[Docket No. FAA-2012-0182; Directorate Identifier 2012-CE-005-AD; Amendment 39-16958; AD 2012-03-52]

#### **Airworthiness Directives; Mooney Aviation Company, Inc. (Mooney) Airplanes**

**ACTION:** Final rule; request for comments.

Figure 1

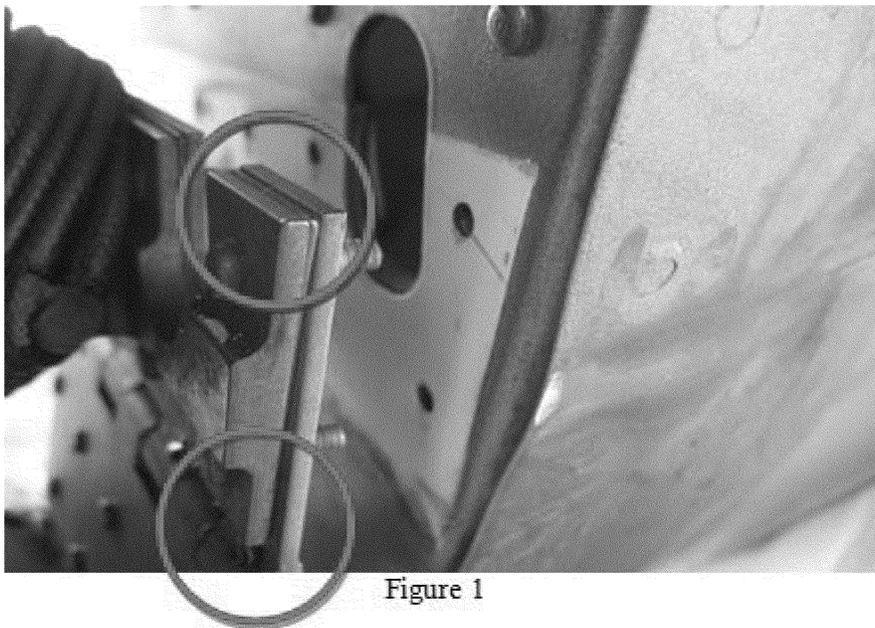
Mooney inspected several other aircraft and found that on one airplane the filler plate was incorrectly installed. The filler plate was not correctly installed between the aft side of the hinge and the bulkhead. Instead, the filler plate was located on the forward side of the hinge between the hinge and trim fitting. It was then noted the incident aircraft had the same issue, as shown in the upper circle of figure 1.

Because the hinge has a lip on the bottom, on the side toward the bulkhead (as shown in the bottom circle of figure 1), if the filler plate is not installed correctly, the hinge will not fit flush against the bulkhead, the Huck Bolt fasteners will not fit perpendicular to the bulkhead, and the collars will not swage properly. The condition also causes excessive tension pre-load on the Huck Bolts.

Before further flight after receipt of this AD, inspect the trim fitting, hinge, and filler plate of the tail pitch trim assembly for correct positioning and proper attachment; and also inspect that the Huck Bolt fasteners are properly secured following Mooney Aviation Company, Inc. Service Bulletin No. M20–313, dated February 7, 2012.

If during the inspection required in paragraph (g) of this AD you find incorrect positioning or improper attachment of the trim fitting, hinge, and filler plate of the tail pitch trim assembly; and/or you find loose or improperly installed Huck Bolt fasteners, before further flight, contact Mooney for FAA-approved repair instructions and perform the repair. Use the contact information found in paragraph (n)(2) of this AD.
